THE HONG KONG HOUSING AUTHORITY

Memorandum for the Building Committee

New Cruciform Block Revised Kitchen & Bathroom Layouts and Design Amendments

NEW CRUCIFORM BLOCK

● FLAT A 2 bedroom flat

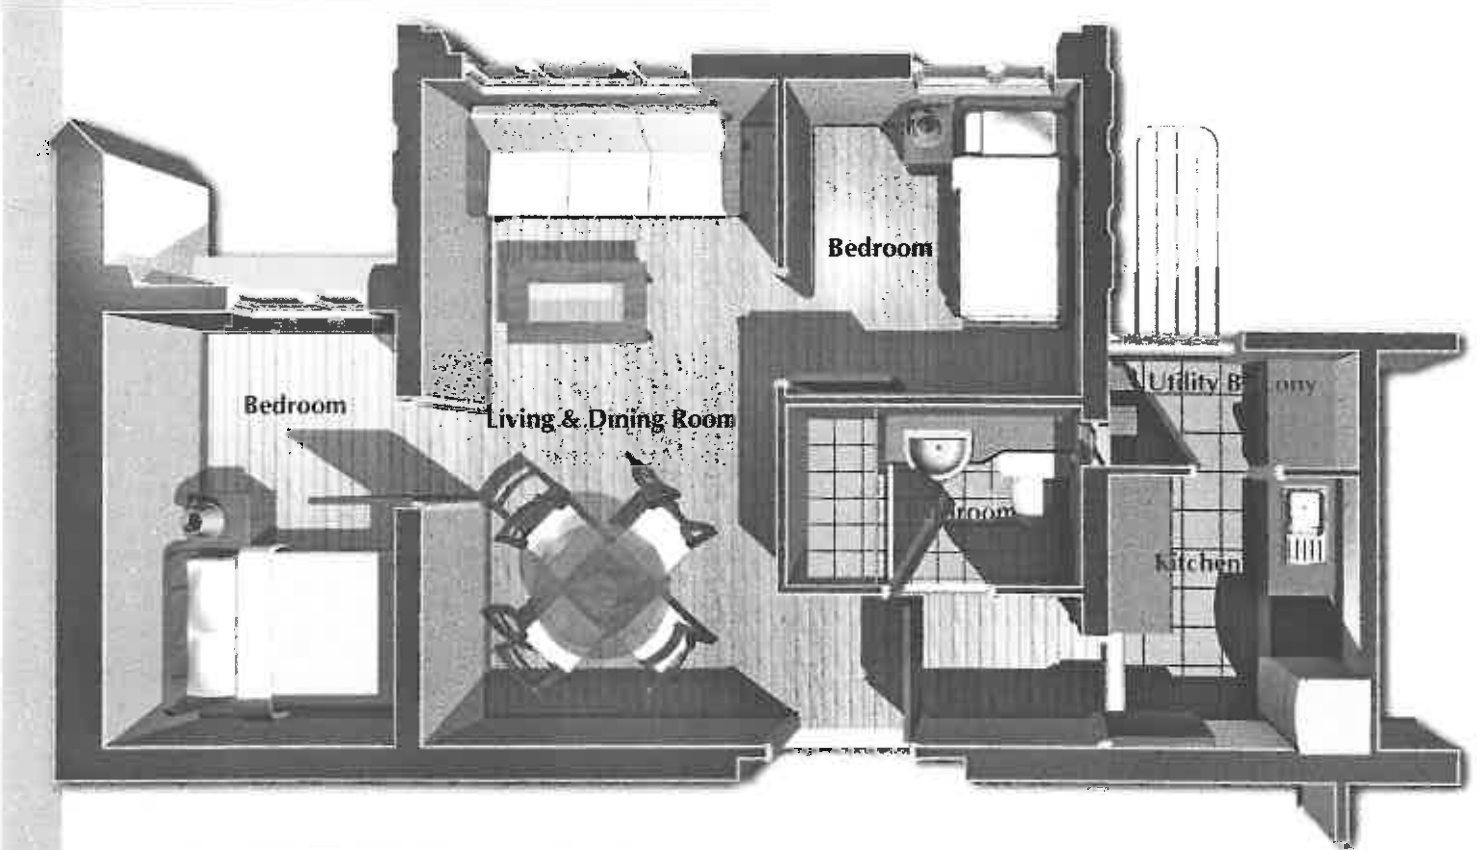
REVISED KITCHEN & BATHROOM LAYOUTS AND DESIGN AMENDMENTS

Kitchen Layout

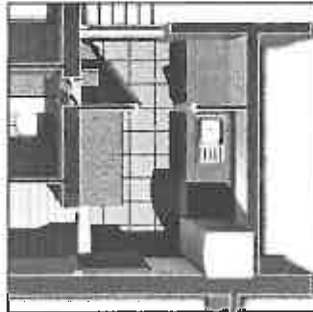
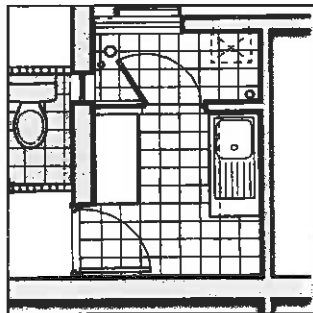
- Revised kitchen layout and cabinet design to accommodate the future electrical household appliances more neatly.
- Additional floor and wall cabinets for more storage space, and additional worktop at the utility balcony.
- To conceal all drainage and services pipes inside the cabinets as far as practicable.
- Postforming laminate worktop with inlaid stainless steel sink.

- The floor and wall tiles are revised from 200mm x 200mm homogeneous / ceramic tiles to 300mm x 300mm homogeneous / ceramic tiles.

- All communal drainage pipes originally installed inside duct in the flat and have taken up space are relocated to the external wall.

Bathroom Layout

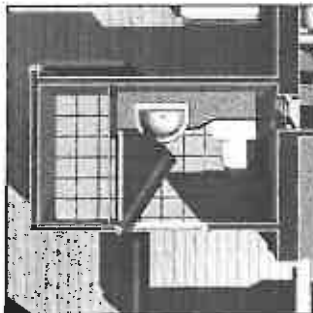
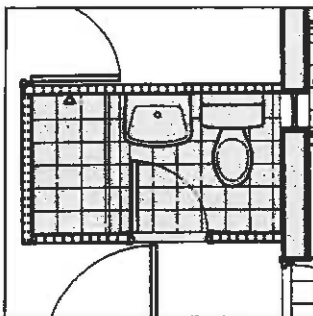
- Provision of shower area and curtain rod.
- Provision of cabinet and postforming laminate worktop in bathroom for more storage space and to conceal all drainage and services pipes inside the cabinet as far as practicable.
- Deletion of mirror cabinet and replaced by a large single piece mirror.

- The floor and wall tiles are revised from 200mm x 200mm homogeneous / ceramic tiles to 300mm x 300mm homogeneous / ceramic tiles.

- All communal drainage pipes originally installed inside duct in the flat and have taken up space are relocated to the external wall.

● **FLAT B** *3 bedroom flat*

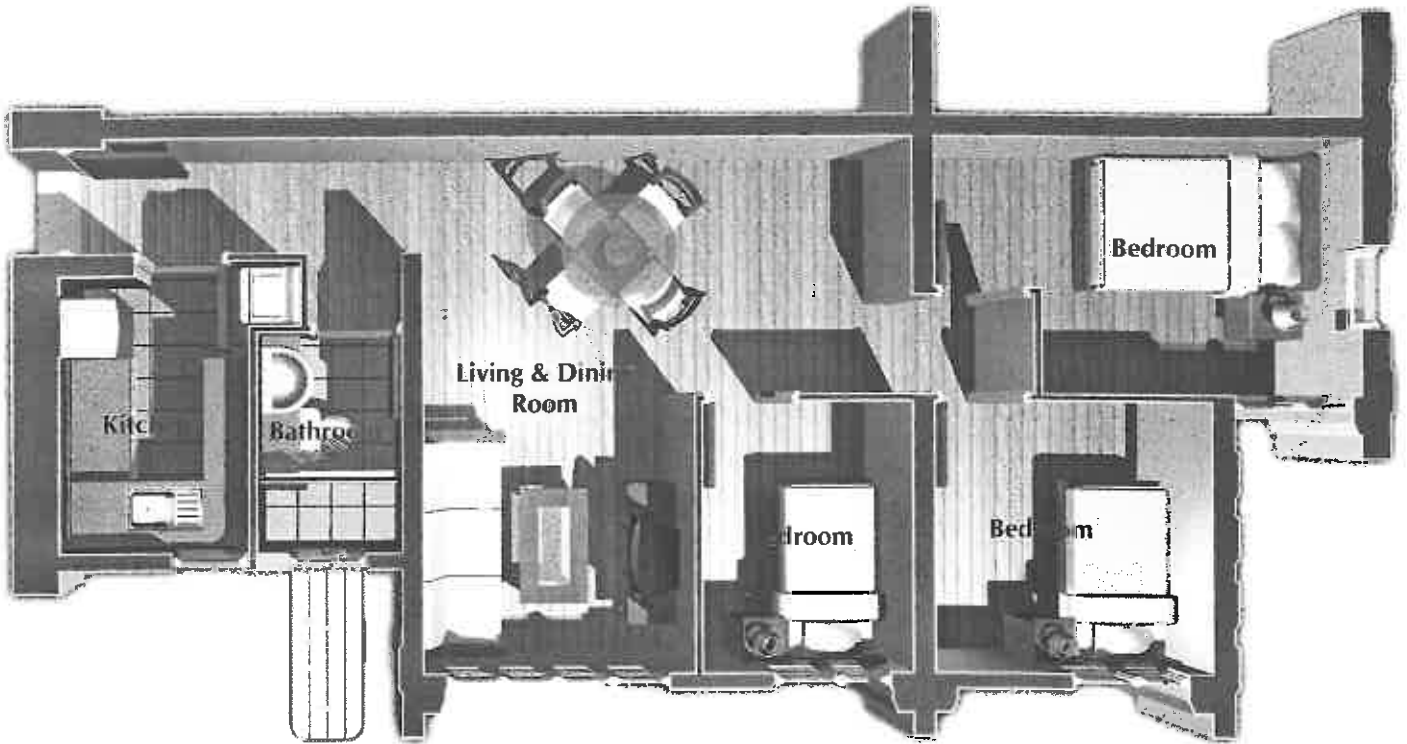
REVISED KITCHEN & BATHROOM LAYOUTS AND DESIGN AMENDMENTS

Kitchen Layout

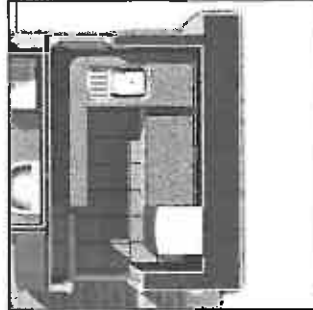
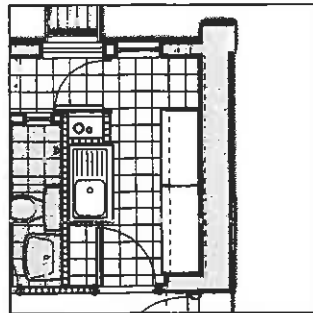
- Revised kitchen layout and cabinet design to accommodate the future electrical household appliances more neatly.
- Additional floor and wall cabinets for more storage space.
- To conceal all drainage and services pipes inside the cabinets as far as practicable.
- Postforming laminate worktop with inlaid stainless steel sink.

- The utility balcony is deleted to allow more space for the kitchen and a more efficient layout. This is also to eliminate the illegal window enclosures commonly provided by the owners.

- The floor and wall tiles are revised from 200mm x 200mm homogeneous / ceramic tiles to 300mm x 300mm homogeneous / ceramic tiles.

- All communal drainage pipes originally installed inside duct in the flat and have taken up space are relocated to the external wall.

Bathroom Layout

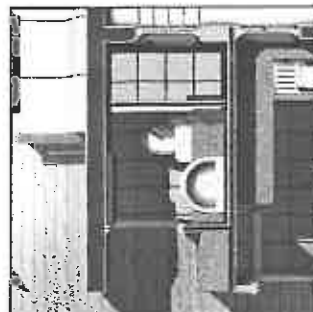
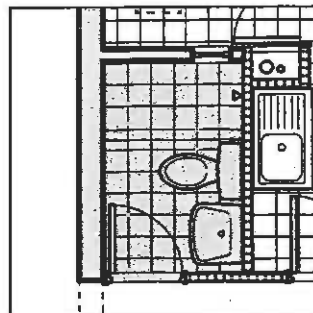
- Provision of shower area and curtain rod.
- Provision of cabinet and postforming laminate worktop in bathroom for more storage space and to conceal all drainage and services pipes inside the cabinet as far as practicable.
- Deletion of mirror cabinet and replaced by a large single piece mirror.
- Additional space for storage cabinet next to the bathroom.

- The floor and wall tiles are revised from 200mm x 200mm homogeneous / ceramic tiles to 300mm x 300mm homogeneous / ceramic tiles.

- All communal drainage pipes originally installed inside duct in the flat and have taken up space are relocated to the external wall.

● FLAT C *3 bedroom flat*

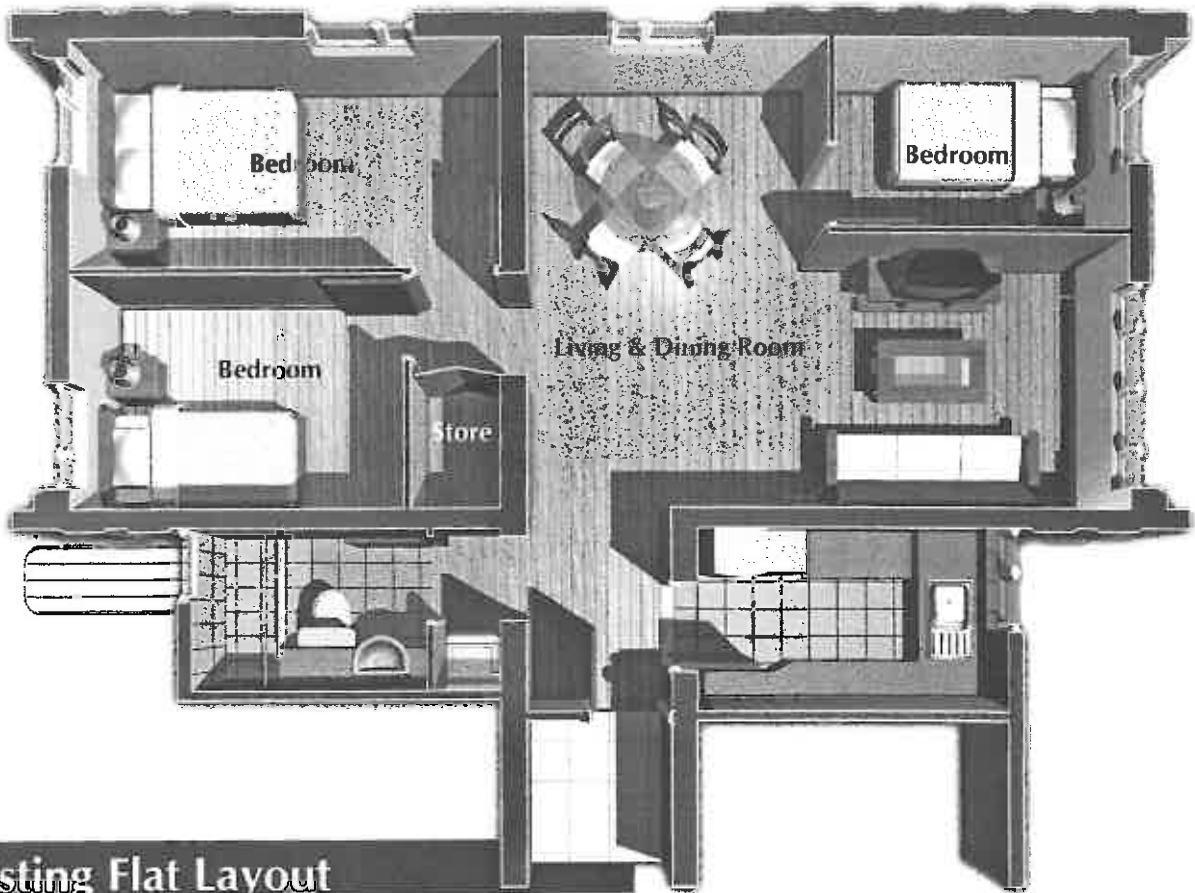
REVISED KITCHEN & BATHROOM LAYOUTS AND DESIGN AMENDMENTS

Kitchen Layout

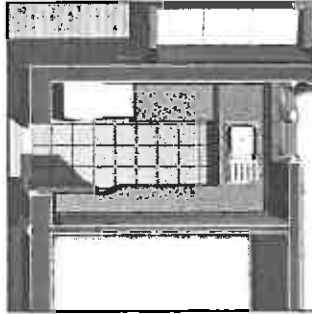
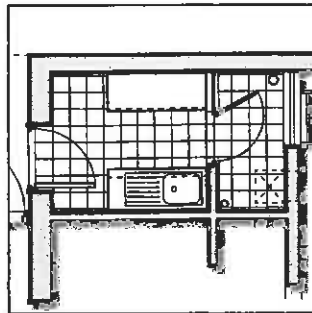
- Revised kitchen layout and cabinet design to accommodate the future electrical household appliances more neatly.
- Additional floor and wall cabinets for more storage space.
- To conceal all drainage and services pipes inside the cabinets as far as practicable.
- Postforming laminate worktop with inlaid stainless steel sink.

- The utility balcony is deleted to allow more space for the kitchen and a more efficient layout. This is also to eliminate the illegal window enclosures commonly provided by the owners.

- The floor and wall tiles are revised from 200mm x 200mm homogeneous / ceramic tiles to 300mm x 300mm homogeneous / ceramic tiles.

- All communal drainage pipes originally installed inside duct in the flat and have taken up space are relocated to the external wall.

Bathroom Layout

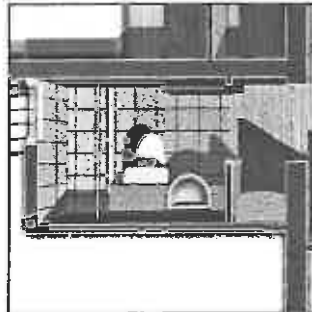
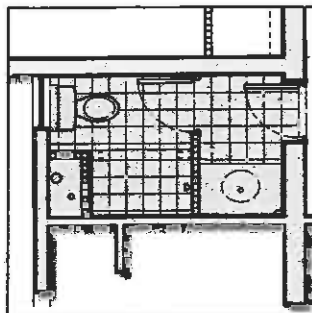
- Provision of shower area and curtain rod.
- Provision of cabinet and postforming laminate worktop in bathroom for more storage space and to conceal all drainage and services pipes inside the cabinet as far as practicable.
- Deletion of mirror cabinet and replaced by a large single piece mirror.
- Additional space for storage cabinet next to the bathroom.

- The floor and wall tiles are revised from 200mm x 200mm homogeneous / ceramic tiles to 300mm x 300mm homogeneous / ceramic tiles.

- All communal drainage pipes originally installed inside duct in the flat and have taken up space are relocated to the external wall.
